Access Compliance Report

Public Rights-of-Way

Intersection ID: 49803	Main Street: ATKINS_RIDGE_DR	Cross Street: MATARESE_CT	Location: W
ADA ID: E7160C590D8F	Ramp Type: Perp	Initial Pass/Fail: Fail	Overall Compliance: No
		Severity Score: 25

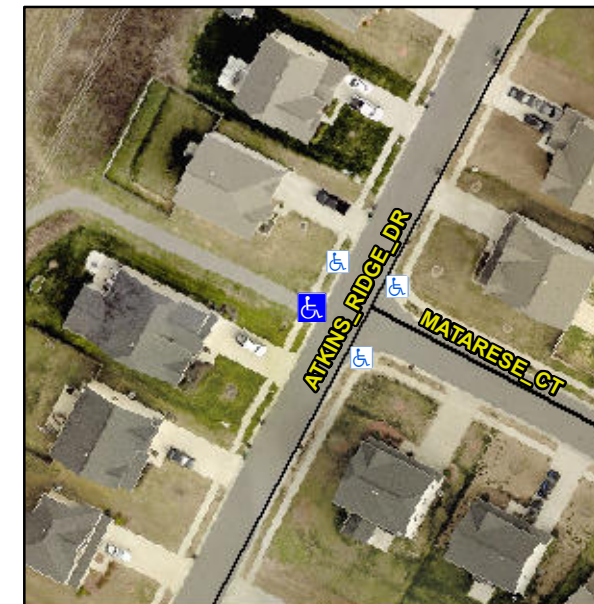
Not Found, R304.2.2, R304.5.3

Compliance	Description	Data	Compliance	Description	Data
N/A	Ramp Length (in)	47.0	No	Ramp Slope (%)	8.6
Yes	Ramp Width (in)	48.0	No	Ramp XSlope (%)	5.2
N/A	Flare Type LT	N/A	N/A	Flare Type RT	N/A
N/A	Flare Slope LT (%)	N/A	N/A	Flare Slope RT (%)	N/A
N/A	Flare Traversable LT?	N/A	N/A	Flare Traversable RT?	N/A
N/A	Landing Length (in)	N/A	N/A	DWS Provided?	N/A
N/A	Landing Width (in)	N/A	N/A	DWS Contrast?	N/A
N/A	Landing Slope (%)	N/A	N/A	DWS Length (in)	N/A
N/A	Landing X Slope (%)	N/A	N/A	DWS Full Width?	N/A
N/A	Landing Curb? (Y/N)	N/A	N/A	DWS Offset (in)	N/A
N/A	Shared Landing?	N/A			
N/A	Gutter Ponding?	N/A	N/A	Gutter Slope (%)	N/A
N/A	Gutter Lip Ht (in)	N/A	N/A	Gutter X Slope (%)	N/A
N/A	Painted X Walk1?	No	N/A	Painted X Walk2?	N/A
	X Walk 1 Direction	To SE		X Walk 2 Direction	N/A
N/A	X Walk 1 Width (in)	N/A	N/A	X Walk 2 Width (in)	N/A
	X Walk 1 Slope (%)	3.3		X Walk 2 Slope (%)	N/A
	X Walk 1 X Slope (%)	6.0		X Walk 2 X Slope (%)	N/A

Remove & Replace Entire Ramp.
